SLG47004-A Errata Note

This document contains the known errata for SLG47004-A and the recommended workarounds.

Figure 1. Inrush Current at V_{DDA} Slew Rate = $1 \text{ V}/\mu\text{s}$

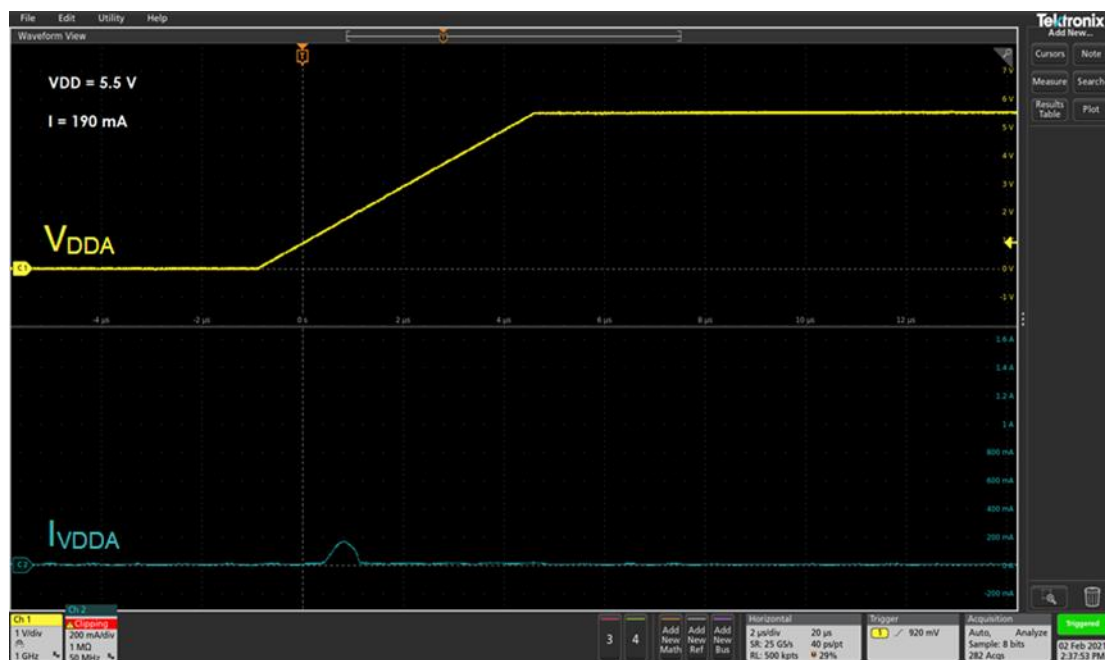
When powering ON the Analog V_{DD} with a slew rate exceeding $1 \text{ V}/\mu\text{s}$, a large inrush current exceeding 190 mA flows through the analog circuitry's ESD power clamp structure. With faster slew rates ($2 \text{ V}/\mu\text{s}$), the inrush current through V_{DDA} can reach 890 mA .

For larger slew rates and higher temperatures, this behavior can permanently damage the SLG47004-A by creating a low impedance path between the power supply rails. This damage is caused by bipolar snapback within the ESD protection device. For this reason, Renesas has introduced an Abs. Max. parameter in the SLG47004-A's base die datasheet specifying a maximum slew rate of $2 \text{ V}/\mu\text{s}$ on V_{DDA} .

To avoid this behavior, we recommend limiting the Analog V_{DD} 's slew rate to a value lower than $2 \text{ V}/\mu\text{s}$, as this will protect the SLG47004-A while limiting inrush current. This can be done by many methods including the use of slew rate limited analog switches or DC/DC converters. Alternatively, you could increase the capacitance on the SLG47004-A's Analog VDD line and place a series resistance on the output of the power supply. Note that this resistor will introduce additional power loss to the system and will cause voltage noise on the analog power rail.
